TENNESSEE VALLEY AUTHORITY
DOCKET NO. 50-260
BROWNS FERRY NUCLEAR PLANT, UNIT 2
AMENDMENT TO FACILITY OPERATING LICENSE

Amendment No. 181
License No. DPR-52

Attachment:
Changes to the Technical
Specifications

Date of Issuance: December 18, 1990

APRM Flow Reference Scram and APRM Rod Block Settings
 Fig. 2.1-1

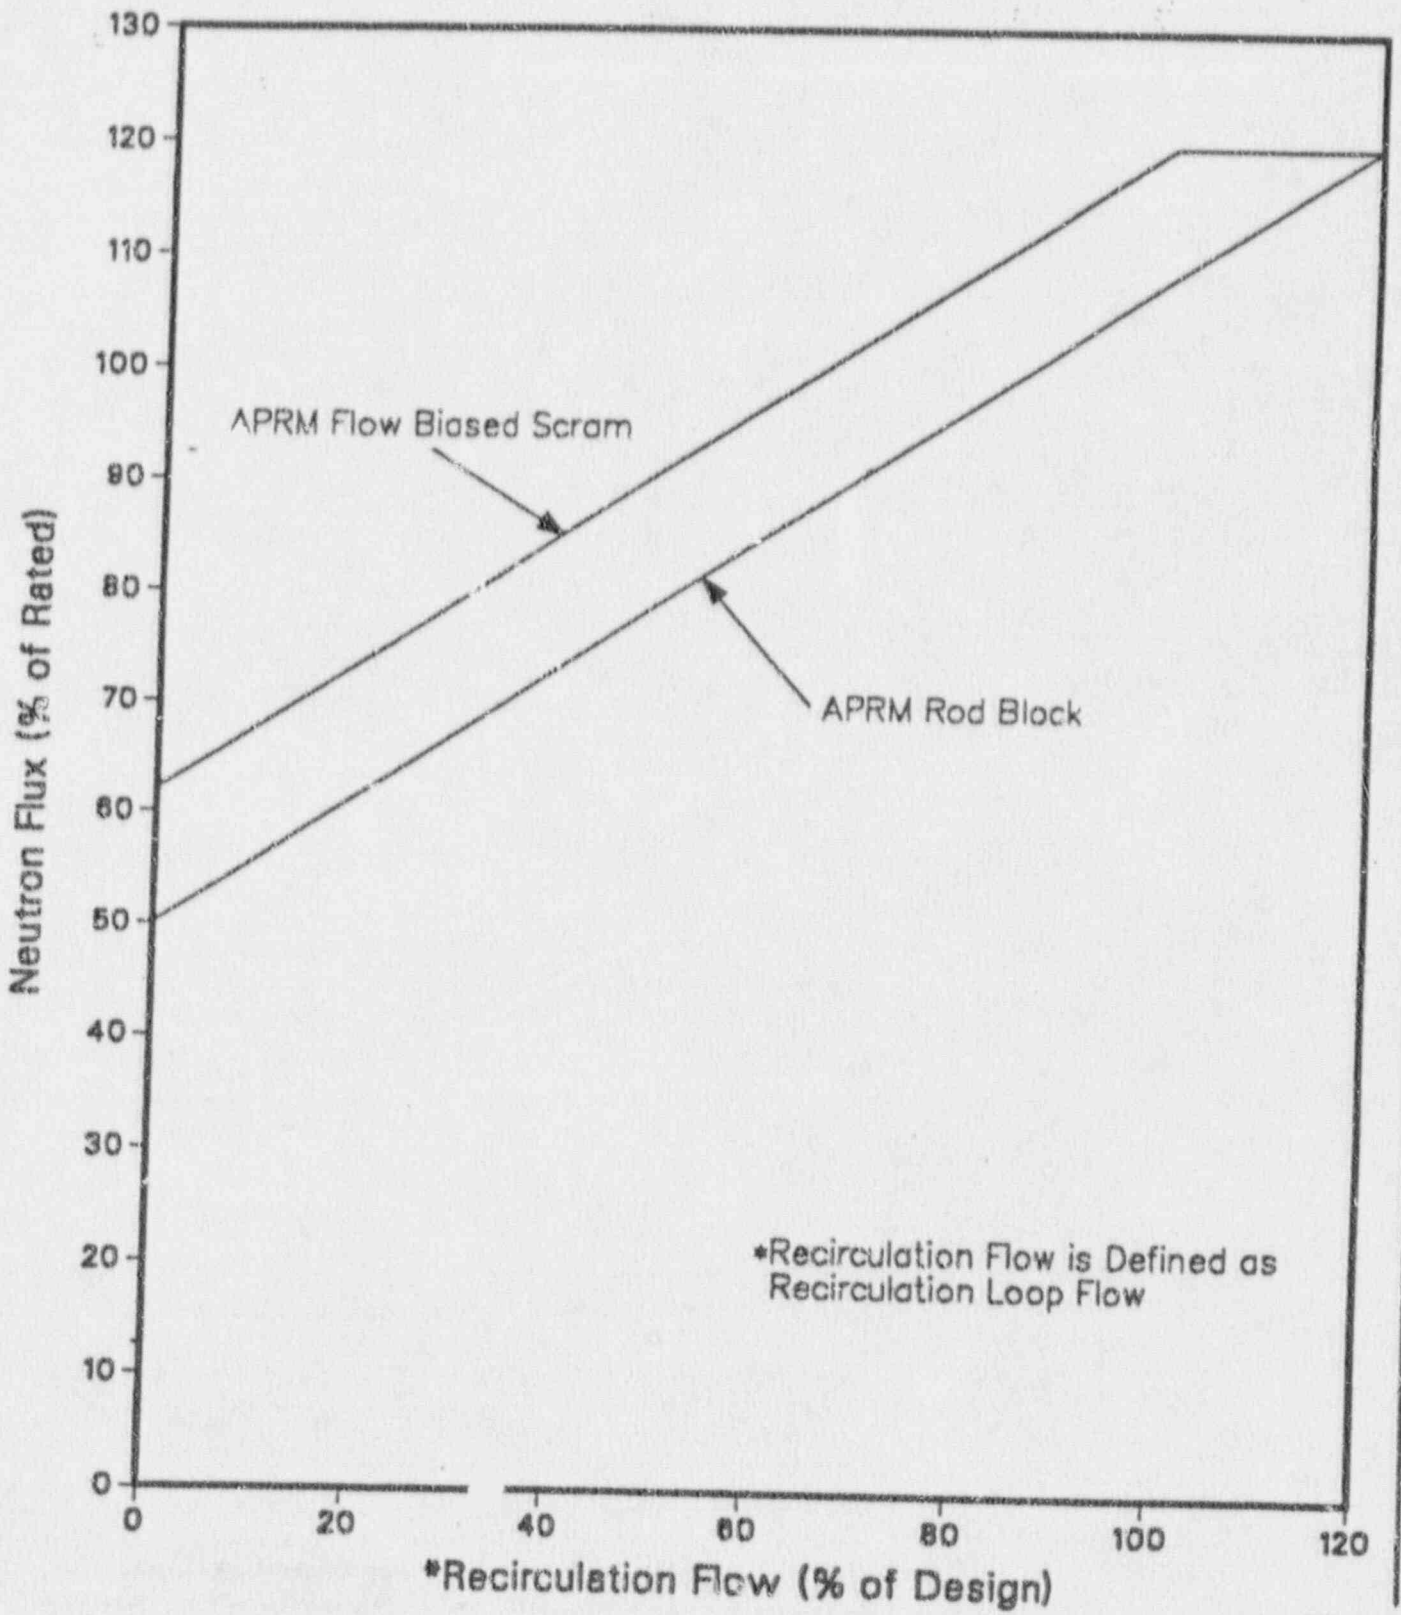
$$S \leq (0.58W + 62\%)$$

$$SRBS \leq (0.58W + 50\%)$$
